## **STAFF REPORT**

**Case No.:** 19-SU-04

**Request:** Conduct a public hearing and consider the request for a Specific Use Permit and associated Detailed Site Plan for an office/warehouse building on an approximately 8.4-acre tract located on the north side of Valley View Lane and on the south side of Keenan Bridge Road, approximately 500 feet east of Luna Road; and take appropriate action.

**Planning & Zoning Commission Meeting:** May 20, 2019

#### *Special Exception #1 – II.B.5 – Parking*

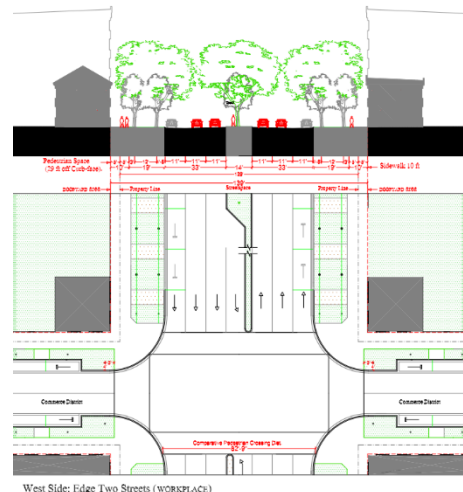
The CZO/PD-88 zoning requires minimum number of parking spaces for each use proposed (office and warehouse) based on gross floor area. The office area is required to have a minimum of 16 parking spaces and the warehouse is required a minimum of 155 parking spaces, thus a minimum total of 171 spaces is required.

The applicant is seeking approval of a special exception to allow for a total of 168 parking spaces.

Staff believes that the requested special exception is appropriate given the proportion of the request. Three parking spaces is 1.7% of the total 171 parking spaces required. Additionally, the applicant would likely have to remove additional trees and encroach the required parking setback in order to accommodate the three spaces.

### ***Special Exception #5 – V.E. – Windows and Doors***

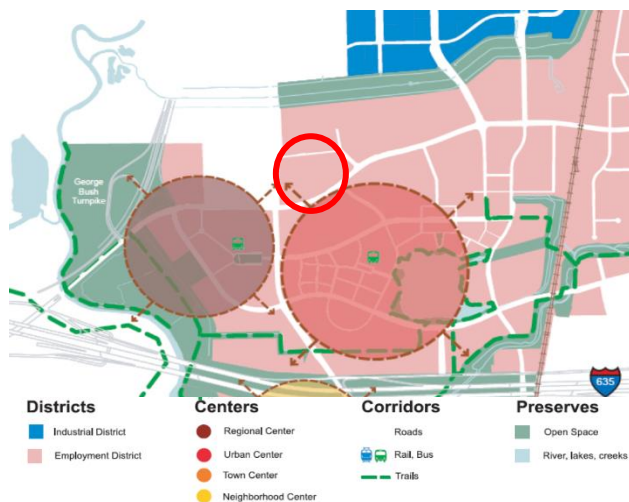
PD-88 zoning requires that openings/windows visible from the street-space, in this case Valley View Lane, not have a horizontal dimension that exceeds the vertical dimension.

The applicant is seeking approval of a special exception to allow for the horizontal dimension of an opening to exceed the vertical dimension.

Staff believes that the requested special exception is appropriate due to the use and corresponding building design that is proposed.
